**STAFF REPORT
KETCHUM PLANNING AND ZONING COMMISSION
REGULAR MEETING OF DECEMBER 15, 2020**

PROJECT: Decked Building Addition

FILE NUMBER: P20-078

APPLICATION TYPE: Design Review

SHEET: CS
 DATE: 11/03/20

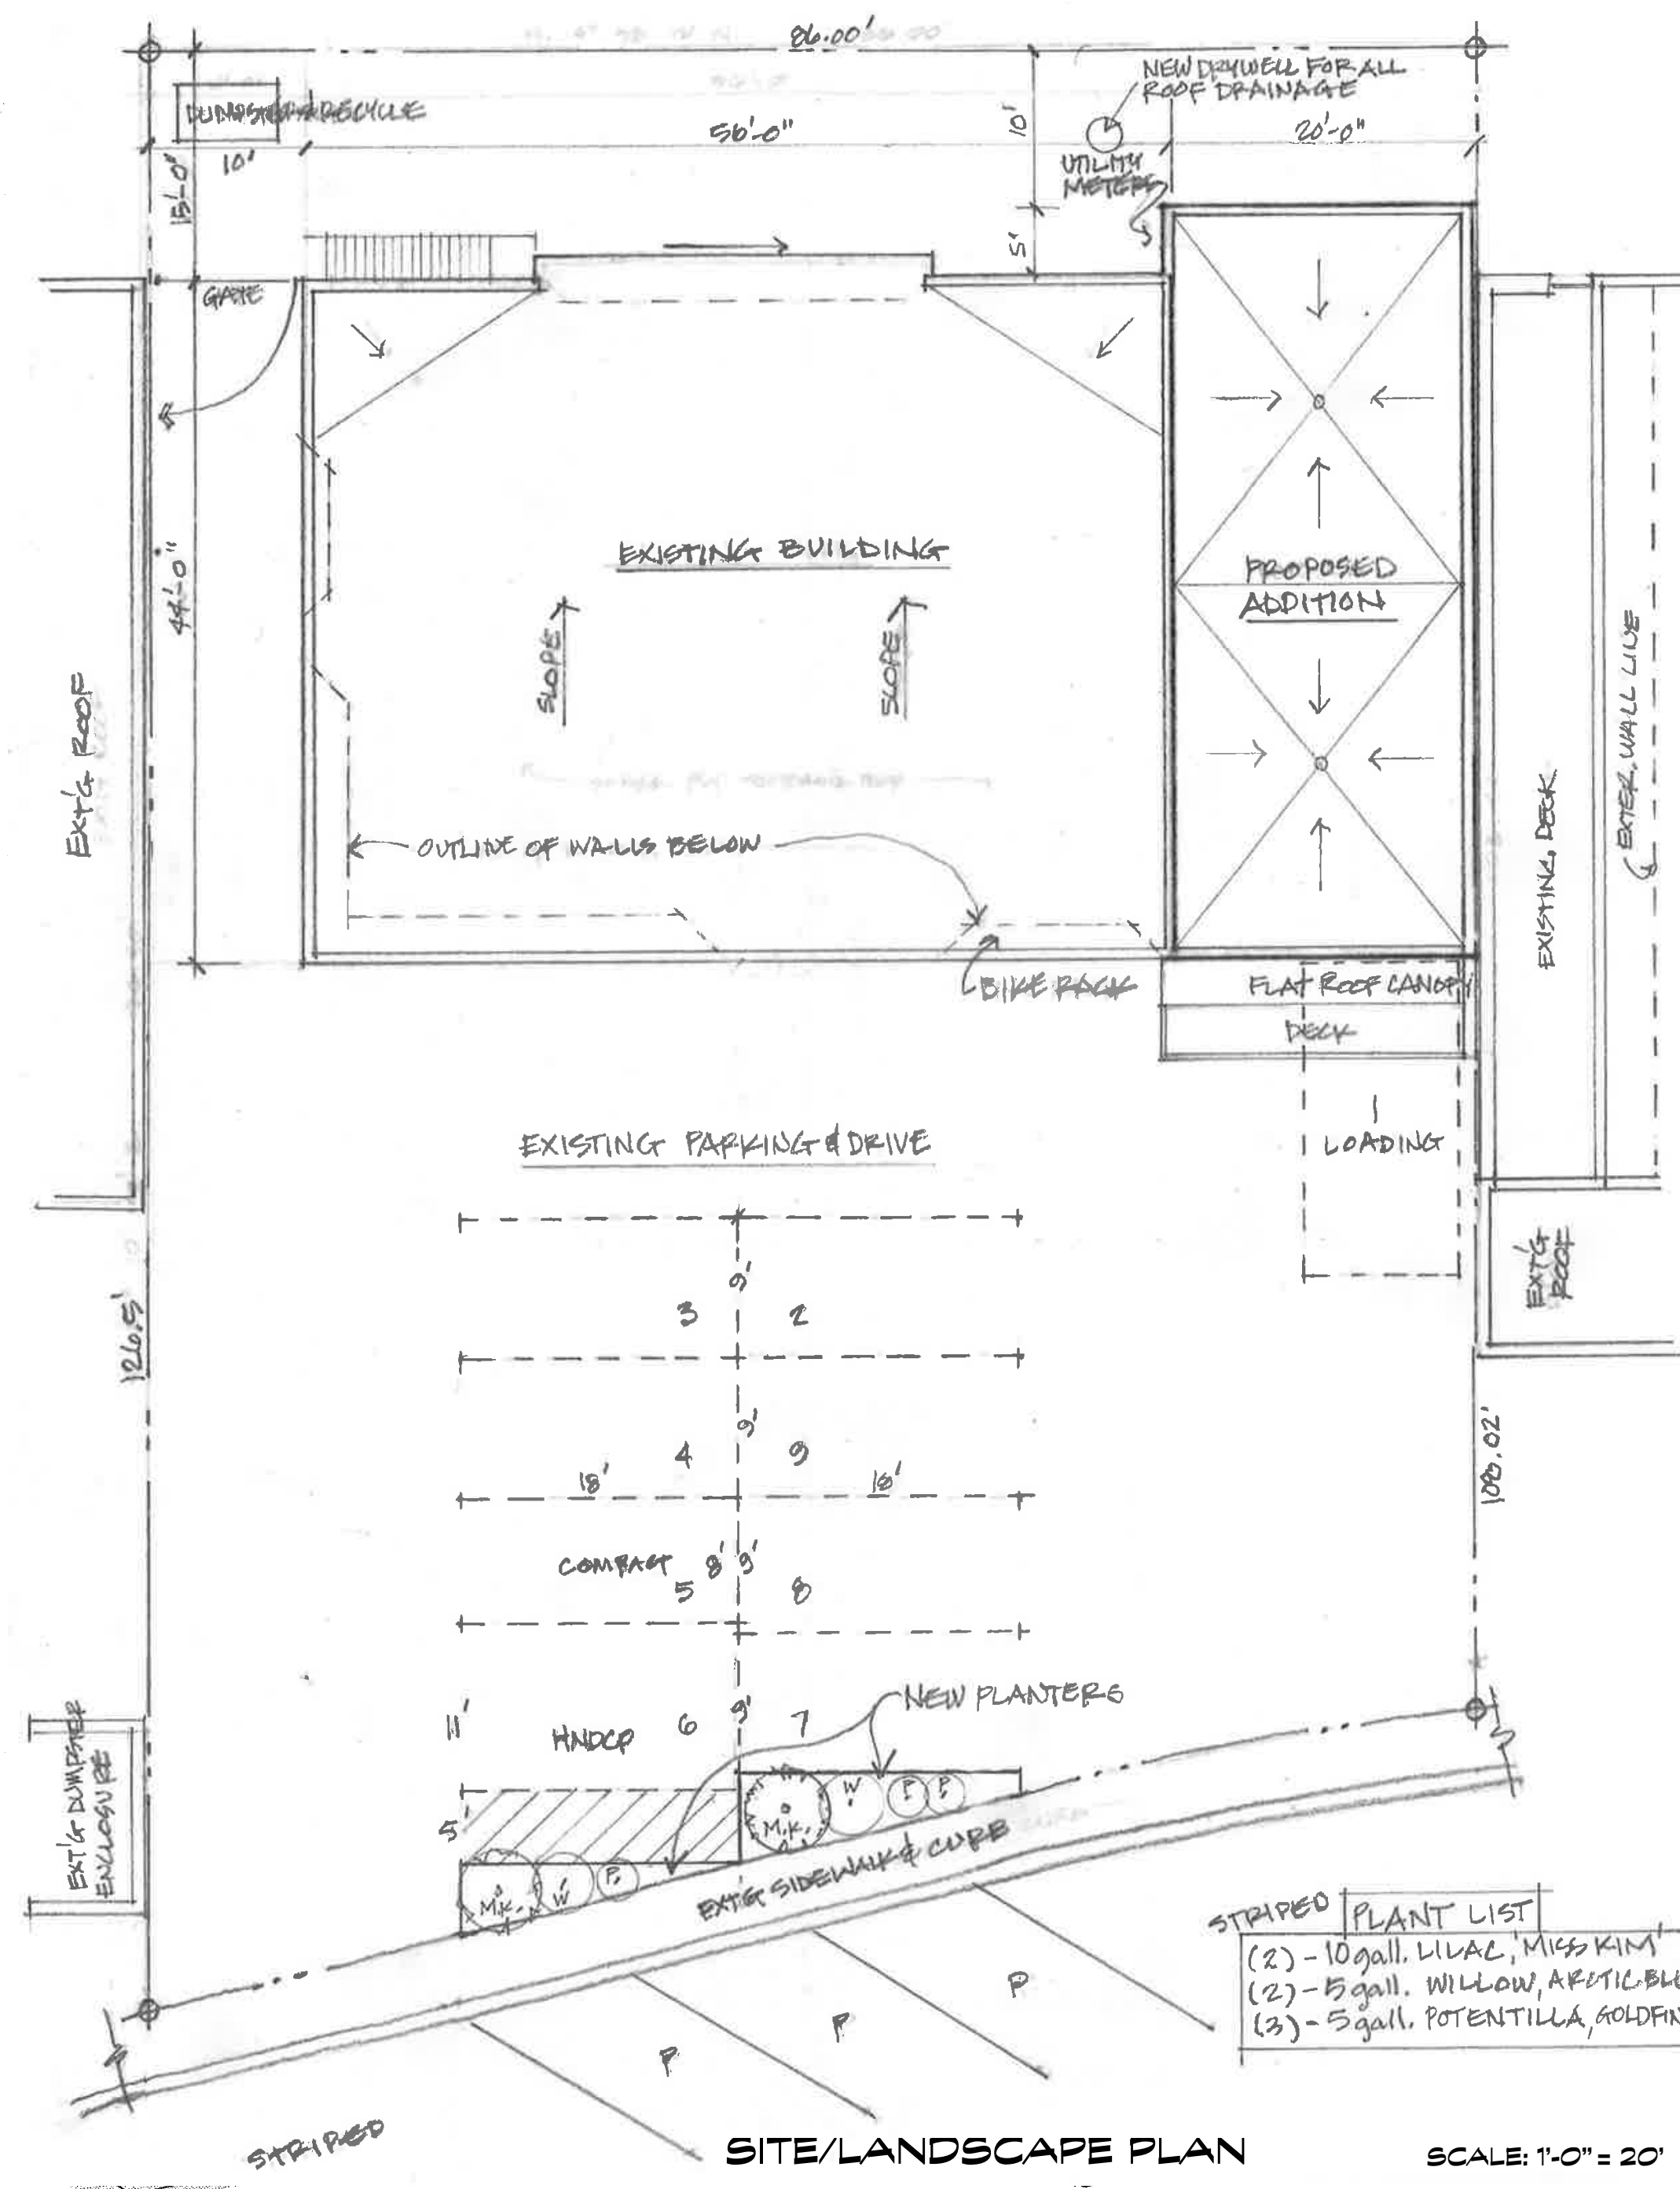
<input checked="" type="checkbox"/>	<input type="checkbox"/>	<input type="checkbox"/>	17.96.060.I1	Landscaping is required for all projects.
			Staff Comments	The landscape plan is indicated on Sheet CS.
<input checked="" type="checkbox"/>	<input type="checkbox"/>	<input type="checkbox"/>	17.96.060.I2	Landscape materials and vegetation types specified shall be readily adaptable to a site's microclimate, soil conditions, orientation and aspect, and shall serve to enhance and complement the neighborhood and townscape.
			Staff Comments	The landscape plan includes new planters bordering the front property line to buffer the surface parking lot from Lewis Street. The plant list includes lilacs, willows, and shrubs. The landscape materials and vegetation types shall be readily adaptable to the site's microclimate, soil conditions, orientation, and aspect.
<input checked="" type="checkbox"/>	<input type="checkbox"/>	<input type="checkbox"/>	17.96.060.I3	All trees, shrubs, grasses and perennials shall be drought tolerant. Native species are recommended but not required.

Staff Comments	The landscape plan is indicated on Sheet CS. The plant list includes lilacs, willows, and shrubs. All proposed landscape materials and vegetation types shall be drought tolerant. The applicant is encouraged to select native species.
<input checked="" type="checkbox"/>	<input type="checkbox"/>	<input type="checkbox"/>	17.96.060.I4	Landscaping shall provide a substantial buffer between land uses, including, but not limited to, structures, streets and parking lots. The development of landscaped public courtyards, including trees and shrubs where appropriate, shall be encouraged.

Staff Comments	The landscape plan is indicated on Sheet CS. The landscape plan includes new planters bordering the front property line to buffer the surface parking lot from Lewis Street. The plant list includes lilacs, willows, and shrubs. Landscaping shall provide a substantial buffer between land uses, including, but not limited to, structures, streets and parking lots. The development of landscaped public courtyards, including trees and shrubs where appropriate, shall be encouraged.
<input type="checkbox"/>	<input type="checkbox"/>	<input checked="" type="checkbox"/>	17.96.060.J1	Where sidewalks are required, pedestrian amenities shall be installed. Amenities may include, but are not limited to, benches and other seating, kiosks, bus shelters, trash receptacles, restrooms, fountains, art, etc. All public amenities shall receive approval from the Public Works Department prior to design review approval from the Commission.

SHEET: A-1
DATE: 8/17/20

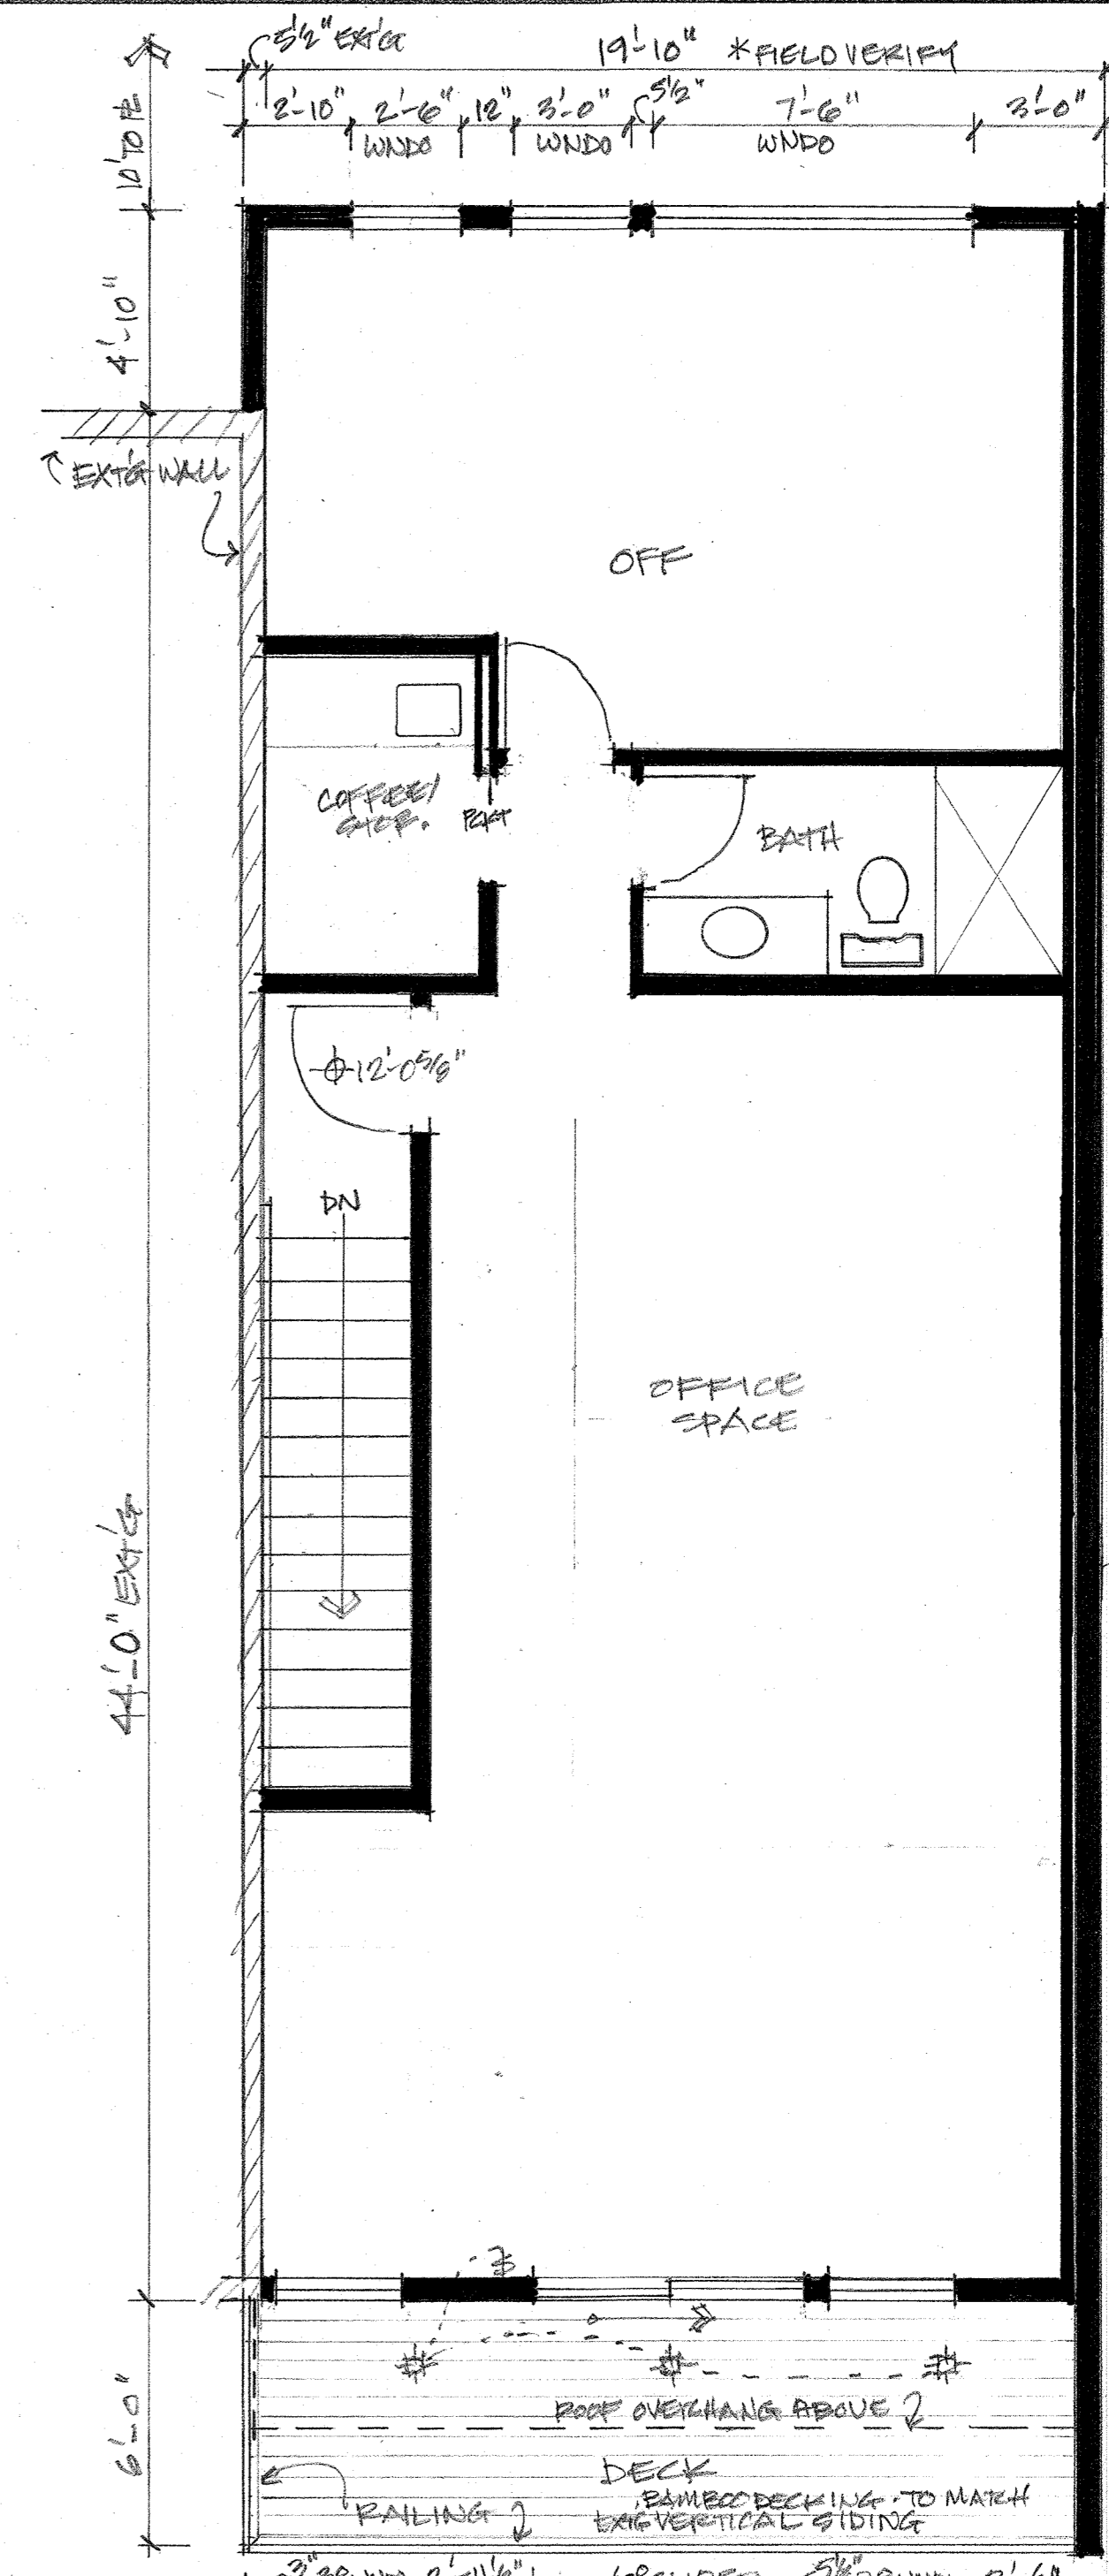
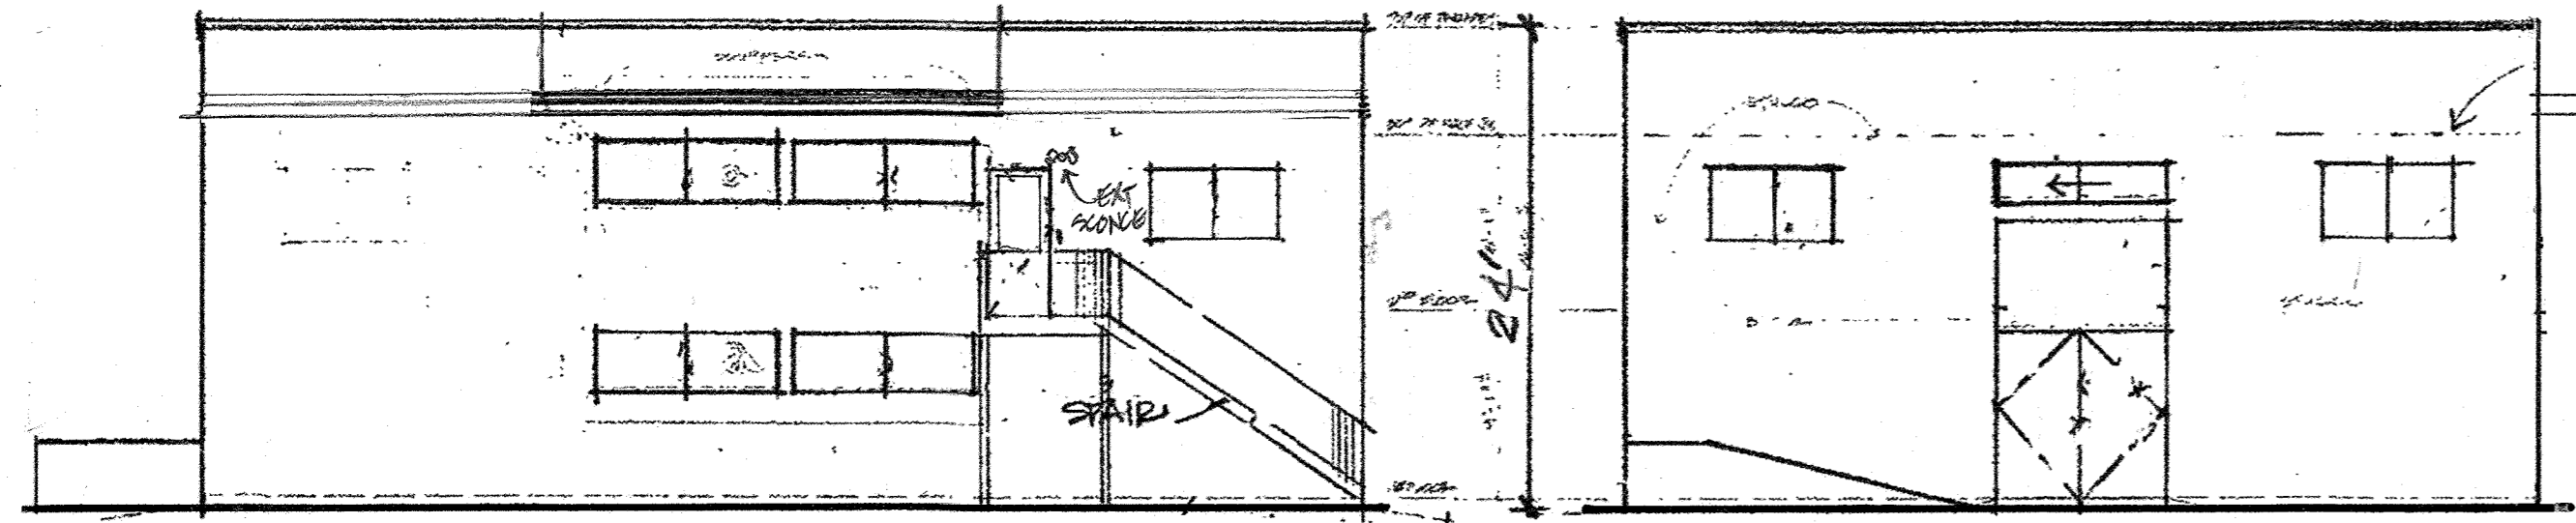
<input checked="" type="checkbox"/>	<input type="checkbox"/>	<input type="checkbox"/>	17.96.060.D2	Utilities shall be located underground and utility, power, and communication lines within the development site shall be concealed from public view.
			Staff Comments	All utilities within the development site shall be underground and concealed from public view. Sheet A-1 of the project plans indicates that utility meters

will be installed at the rear of the addition behind the existing Decked Building. Prior to issuance of a Certificate of Occupancy for the project, Planning & Building Department Staff will conduct an inspection to ensure that all utilities are concealed from public view. See above Staff comment for Ketchum Municipal Code §17.96.060(D)(1).
<input checked="" type="checkbox"/>	<input type="checkbox"/>	<input type="checkbox"/>	17.96.060.D3	When extension of utilities is necessary all developers will be required to pay for and install two (2") inch SDR11 fiber optical conduit. The placement and construction of the fiber optical conduit shall be done in accordance with city of Ketchum standards and at the discretion of the City Engineer.
			Staff Comments	The applicant is aware of this requirement and will comply with these standards.
<input checked="" type="checkbox"/>	<input type="checkbox"/>	<input type="checkbox"/>	17.96.060.E1	The project's materials, colors and signing shall be complementary with the townscape, surrounding neighborhoods and adjoining structures.

Staff Comments	As noted on Sheet A-1 of the project plans, the addition's exterior materials will match the existing building. The two-story addition matches the scale of the existing building with consistent dimensions and box-shaped building form.
<input checked="" type="checkbox"/>	<input type="checkbox"/>	<input type="checkbox"/>	17.96.060.F1	Building(s) shall provide unobstructed pedestrian access to the nearest sidewalk and the entryway shall be clearly defined.
			Staff Comments	The existing building is setback 43 feet from the front property line along Lewis Street. The addition will add an additional entrance to the Decked Building. The building entrances are defined by overhanging elements. The addition project includes a dark bronze steel deck that extends over the entrance to the new addition.
<input checked="" type="checkbox"/>	<input type="checkbox"/>	<input type="checkbox"/>	17.96.060.F2	The building character shall be clearly defined by use of architectural features.
